Technical Bulletin

TB Number: 091
Date Issued: June 11, 2013
Expiration Date: none

Subject/Key Words:	Quick dump door may separate from dump piston – inspect and correct			
Classification:	<input checked="" type="checkbox"/> Informational	<input type="checkbox"/> Mandatory	<input type="checkbox"/> Safety Alert	<input checked="" type="checkbox"/> Preventive Maintenance Impact
	<input type="checkbox"/> Warranty Impact	<input type="checkbox"/> Purchase Parts	<input type="checkbox"/> No Charge For Parts expires ___/___/____. Reference this TB# when ordering NC parts.	
Application:	Gama modules: End-Effector Wash-Dry, and QDR cold and hot/warm/cold			
Parts/Documents:	TNK2B0012 PISTON TANK 1.5"EXT 2"BORE 1.5" STROKE O-RING 2-018 PISTON KALREZ			
Attachments:	none

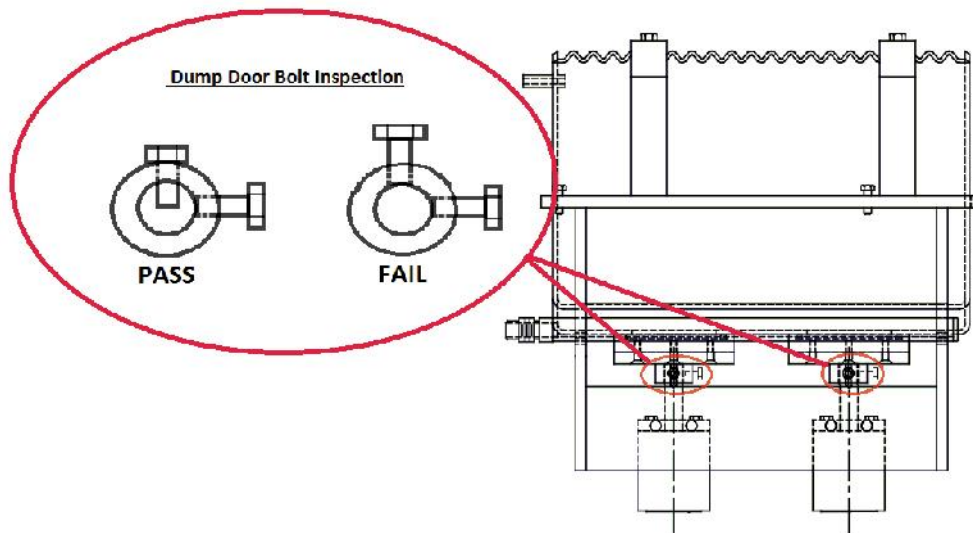
Issue: QDR or EEWD tanks do not fill and/or drain when the dump piston is activated. The Dump piston shaft is missing the set screw blind hole. The set screws may eventually work loose causing the disk (dump door) to remain stuck to the bottom of the tank (does not drain) or become separated from the shaft (will not fill).

Solution 2: Solution 1 reveals the piston shaft to be missing the ¼ inch side hole

- Open dump doors and remove “Failed” dump door from piston shaft
- Note/mark position of piston to mounting plate
- Remove four HH bolts securing piston to the mounting plate
- Note/mark top and bottom air lines to the piston for correct re-assembly
- Remove piston and drill a ¼ inch blind hole per diagram below and de-burr
- Reverse disassembly process to assemble and test
